# DART SERVICE INSTRUCTION

TO AMEND INSTALLATION INSTRUCTIONS IIN-D350-616 REV. C

A	NEW ISSUE (NCR 10-062)		CP	10.08.12
REV.	DESCRIPTION		BY	DATE
DESIGN	99	<b>DART AEROSPACE LTD</b> HAWKESBURY, ONTARIO, CANADA		
DRAWN	99			
CHECKED	N/A	DRAWING NO.	REV. A	
MFG. APPR.		DSI 9530	SHEET 1 OF 1	
APPROVED		TITLE	SCALE	
DE APPR.		PATIENT STOP REPLACEMENT	NTS	
DATE	10.08.12		COPYRIGHT © 2010 BY DART AEROSPACE LTD	
THIS DOCUMENT IS PRIVATE AND CONFIDENTIAL AND IS SUPPLIED ON THE EXPRESS CONDITION THAT IT IS NOT TO BE USED FOR ANY PURPOSE OR COPIED OR COMMUNICATED TO ANY OTHER PERSON WITHOUT WRITTEN PERMISSION FROM DART AEROSPACE LTD.

**FIGURE 1: LITTER ASSEMBLY**  
(VIEW LOOKING DOWN)

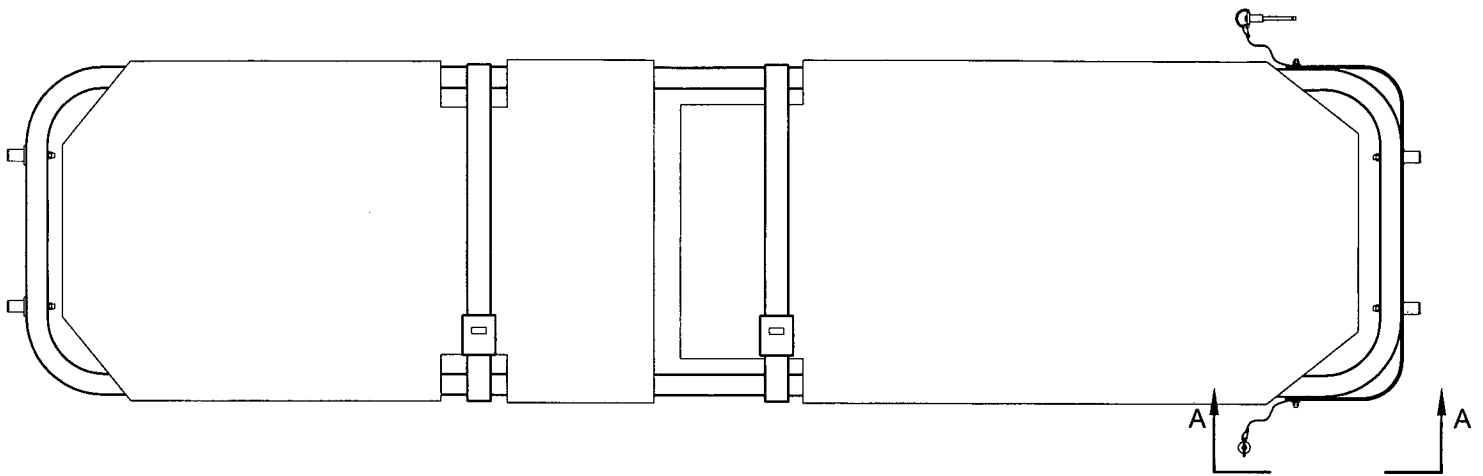
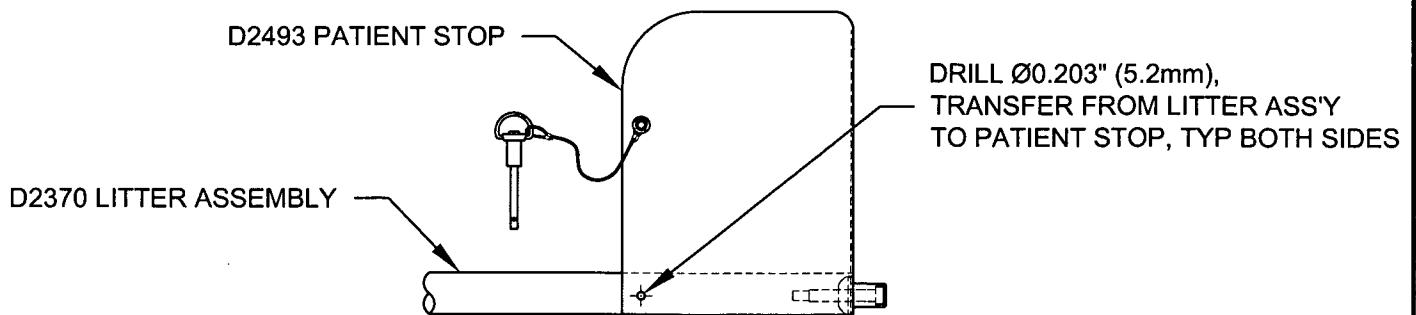
IF REPLACING THE D2493 PATIENT STOP, IT MAY BE NECESSARY TO TRANSFER DRILL THE PIP PIN ATTACHMENT HOLE FROM THE D2370 LITTER ASSEMBLY TO THE D2493 PATIENT STOP. DRILL Ø0.203" (5.2mm) TO MATCH HOLE IN LITTER ASSEMBLY. TOUCH-UP PAINT AS REQUIRED TO MATCH ORIGINAL FINISH.
